Accessibility Report for the 117th Congress

on Americans
with Disabilities
Act Public
Services and
Accommodations
Inspections

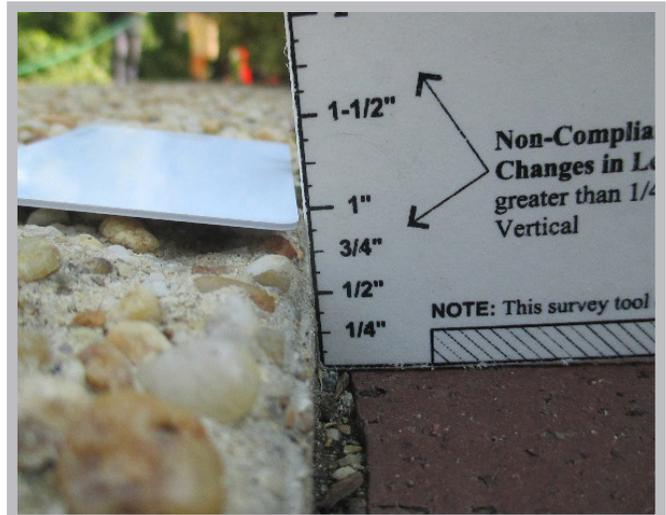
A vertical transition measures 0.875 inches high.

Handrails at a spiral staircase are obstructed by overgrown plants.

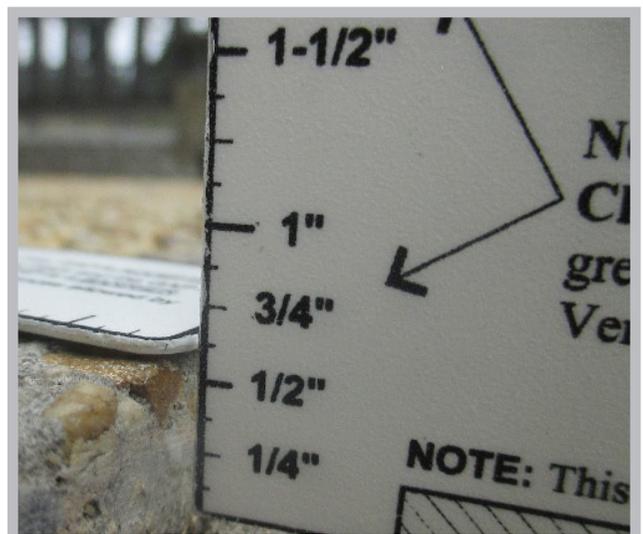
A vertical transition is measured on a sidewalk.

A vertical transition on a sidewalk measures 0.625 inches high.

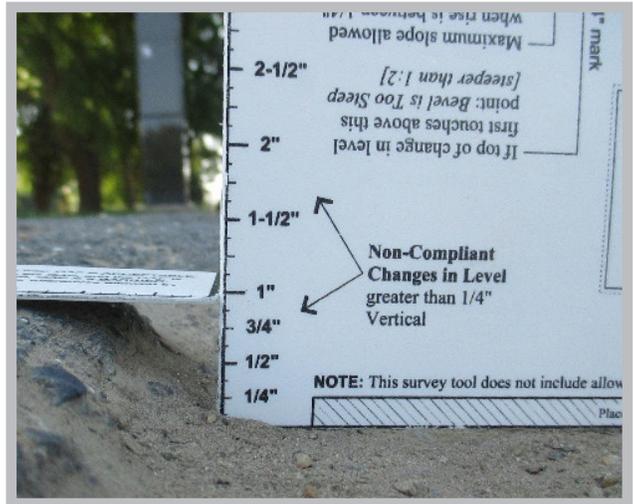
A vertical transition is measured on a sidewalk.

A vertical transition on a sidewalk measures 1 inch high.

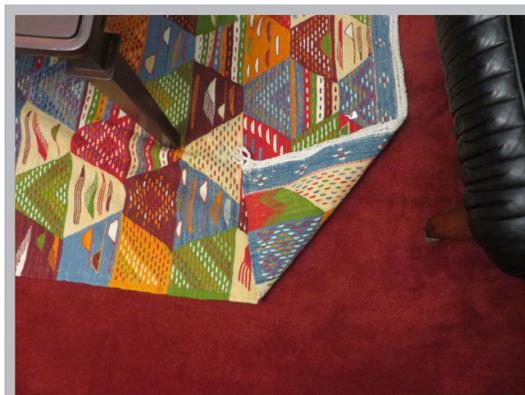
A table's knee clearance measures 25 inches high.

The edge of a rug folds easily and can cause tripping.

A coffee maker measures 54 inches high.
